**UMMC PROJECT NO. 409-007
FIRE PROTECTION CENTRAL CORE
UNIVERSITY OF MISSISSIPPI MEDICAL CENTER
JACKSON, MISSISSIPPI**

Addendum No. 2

August 10, 2026

This addendum forms a part of the contract documents and modifies the original plans and specifications dated June 12, 2026.

**ENLARGED
THIRD FLOOR
PLAN**
sheet no.
A-403.1
of .

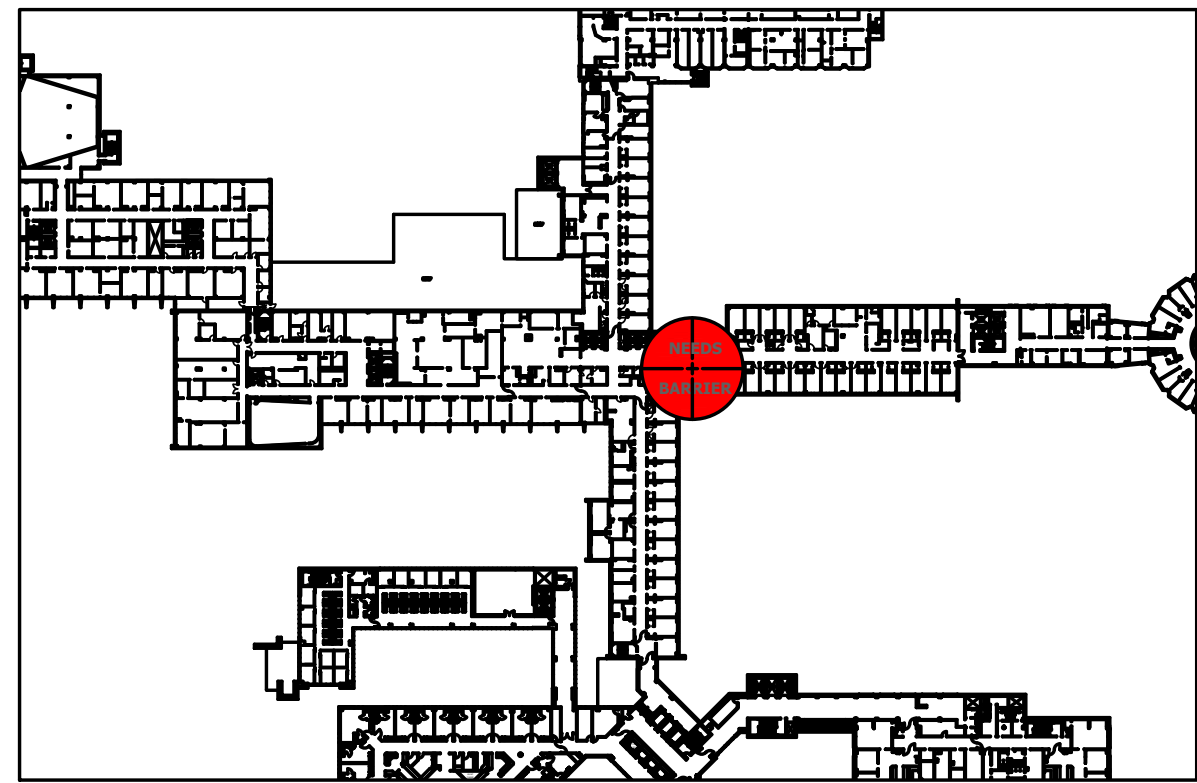
Item 2.8: Drawings A-403.1, A-404.1, A-402.2, and A-601

Add: The enclosed drawings dated August 10, 2026.

AD-2

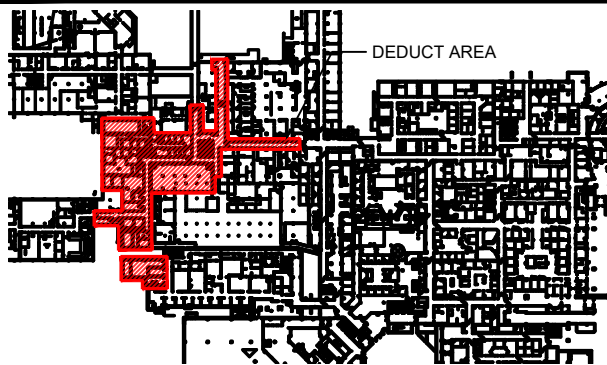
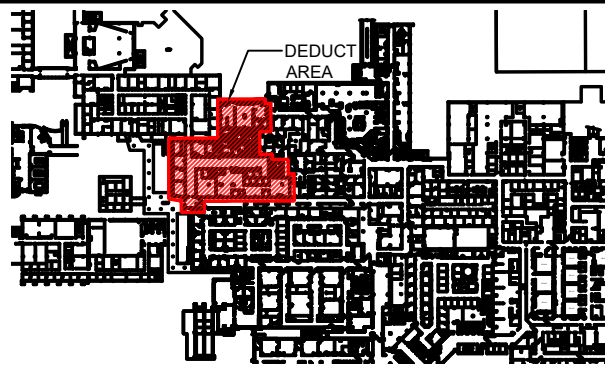
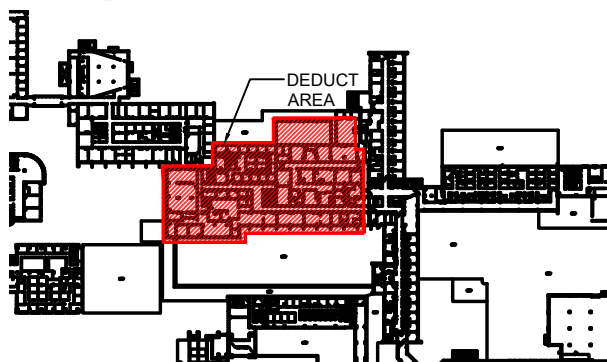
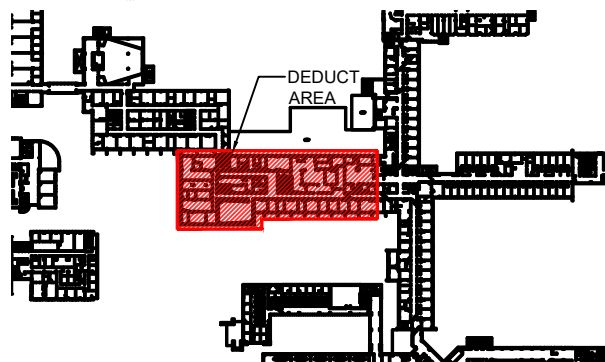
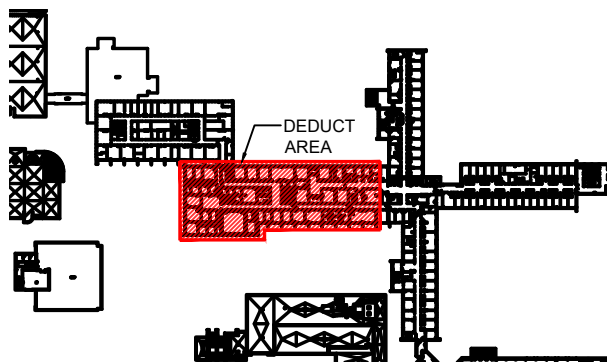
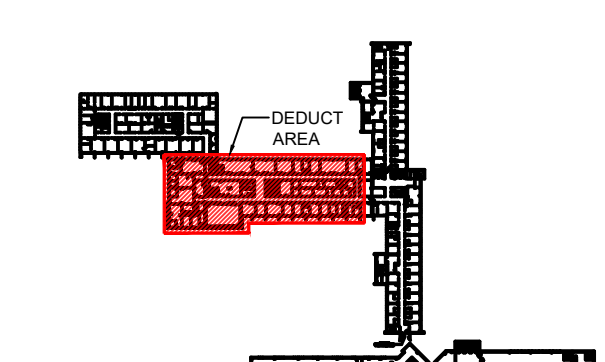
Item 2.9: Drawing AD-2

Add: The enclosed drawings dated August 10, 2026, indicating the floors of the north wing included in Alternate No. 2.
